RE: 1719 5th St. NW
Grading and Drainage Plan
Engineer's Stamp Date: 02/13/22
Hydrology File: H14D100

RE: 1719 5th St NW

GRADING AND DRAINAGE PLAN

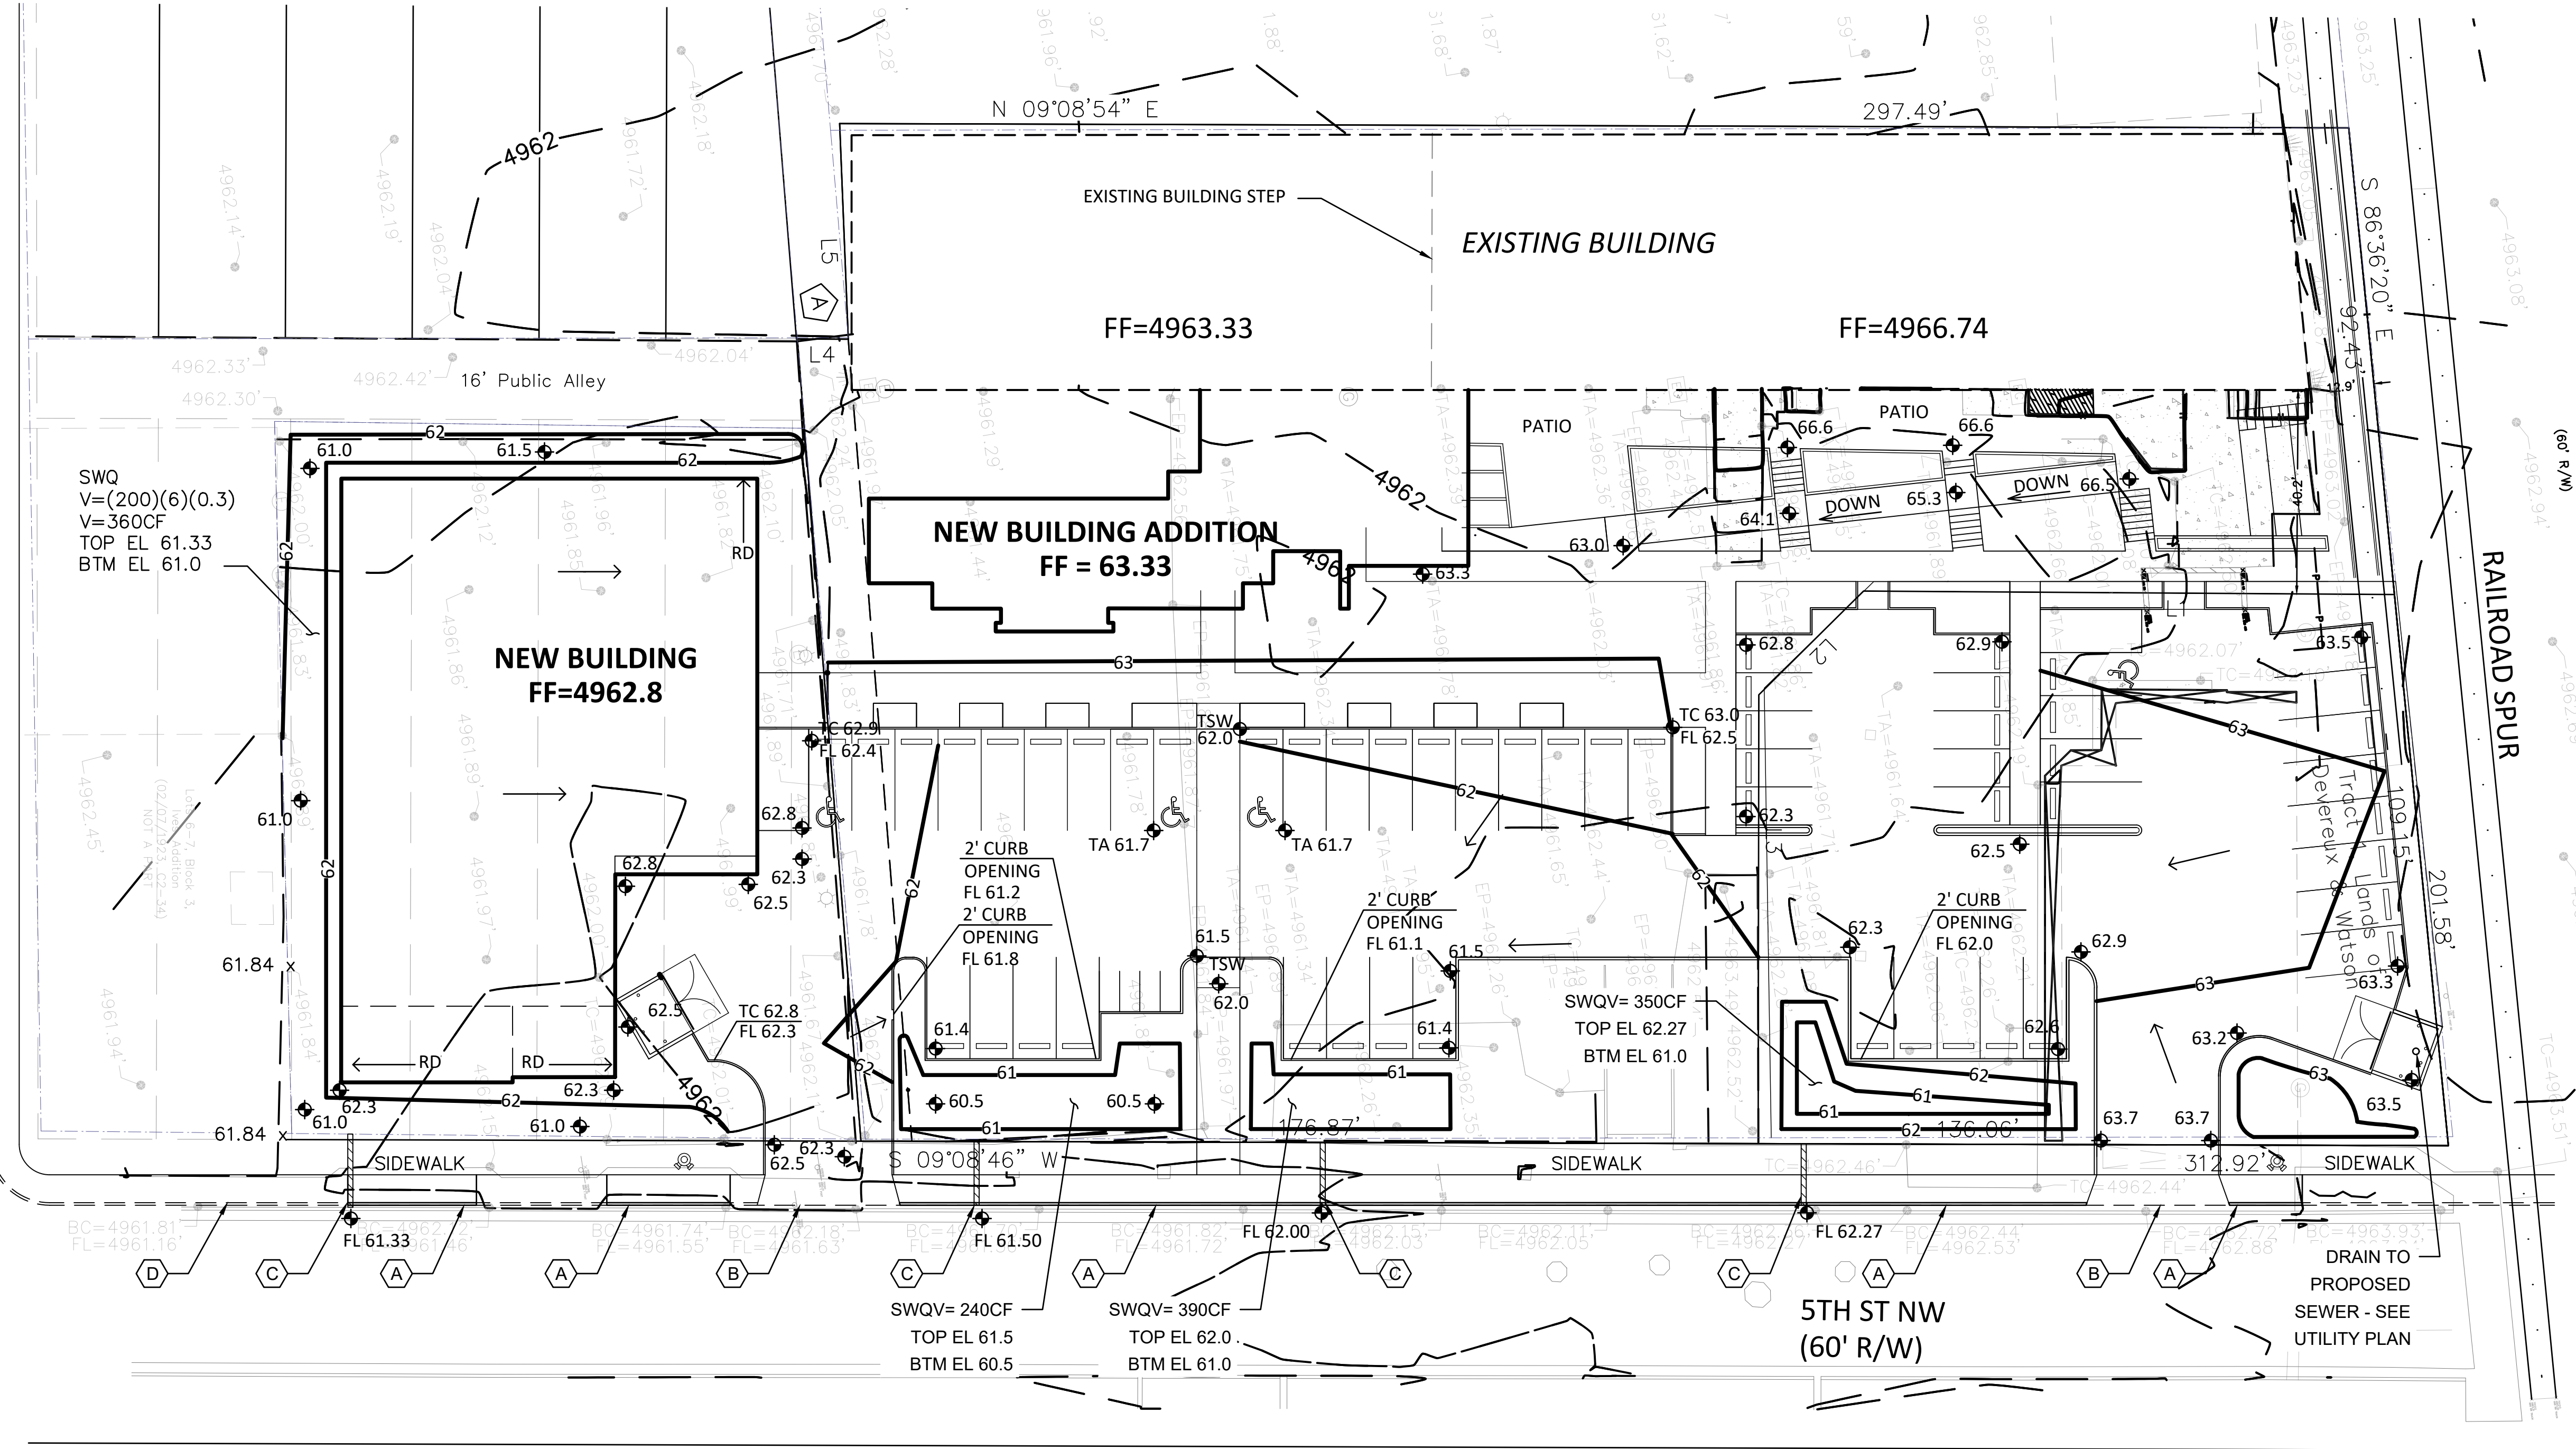
Based upon the information provided in your submittal received 02/28/2022, the Grading & Drainage Plan is approved for Building Permit and SO-19 Permit. Please attach a copy of this approved plan in the construction sets for Building Permit processing along with a copy of this letter.

1. Engineer's Certification, per the DPM Part 6-14 (F): *Engineer's Certification Checklist For Non-Subdivision* is required.
2. Please provide the Drainage Covenant with Exhibit A for the stormwater quality ponds per Article 6-15(C) of the DPM prior to Permanent Release of Occupancy. Please submit the original copies along with the \$ 25.00 recording fee check made payable to Bernalillo County to Marion G. Velasquez (mgvelasquez@cabq.gov) on the 4th floor of Plaza de Sol. Please note that Hydrology will need a pdf copy of the recorded Drainage Covenant prior to Hydrology's approval of Permanent Release of Occupancy.

1. The plan linework has been revised to clarify what is new vs existing.
2. The new building to the south has been added as part of this redevelopment work.
3. The drafting has been revised to show the proposed work within the R/W and Keyed notes have also been added.
4. The TCL plan was approved with the proposed flared driveway (2425) which is attached.
5. SWQ Volumes have been added along with Top/Bottom Pond elevations.
6. City standards have been referenced for sidewalk culverts and elevations are added.
7. A weir calculation has been added for a 12" sidewalk.
8. A note has been added referencing the Utility plan for the refuse drain.
9. An ESC plan will be prepared and submitted.
